Technical Service Bulletin

MODEL(S) AFFECTED: T600/T600e/T600EE Walk-behind Scrubbers

SUBJECT: Squeegee lift mount durability upgrade. Normal wear and tear on the squeegee mount pivot pin and mounting holes may slowly cause the blade pitch to change and eventually affect squeegee performance.

Squeegee Lift Mount

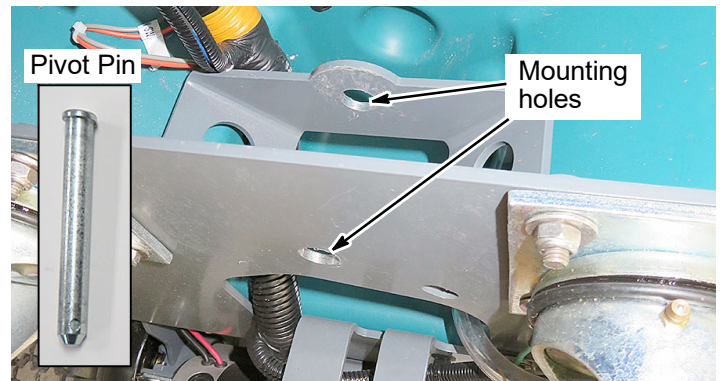
Check pivot pin and mounting holes in frame for wear (i.e. deep grooves in pin and elongated holes). Install the upgrade kit if unable to maintain proper blade roll-out using the blade pitch adjustment as described below. If the adjustment stem is near full adjustment (less than 1 stem rotation remaining) with proper blade roll-out, install kit.

PURPOSE: For customers that have experienced the above condition, install the Squeegee Mount Upgrade Kit p/n 9020916. The upgrade kit is designed with flange bushings to protect pin and frame from wear.

Proper Squeegee Blade Roll-out

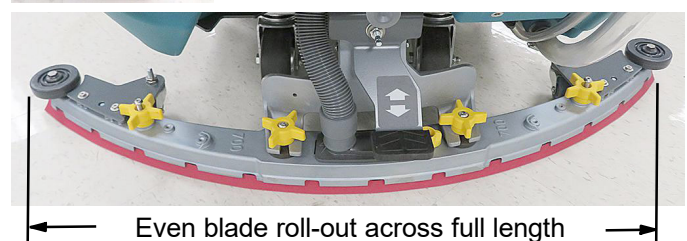
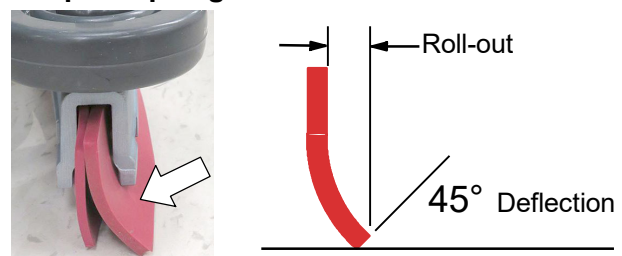
Blade Pitch Adjustment: Turn the pitch adjustment stem counter-clockwise to raise blade tips or clockwise to lower the blade tips. 7mm & 17mm wrenches required.
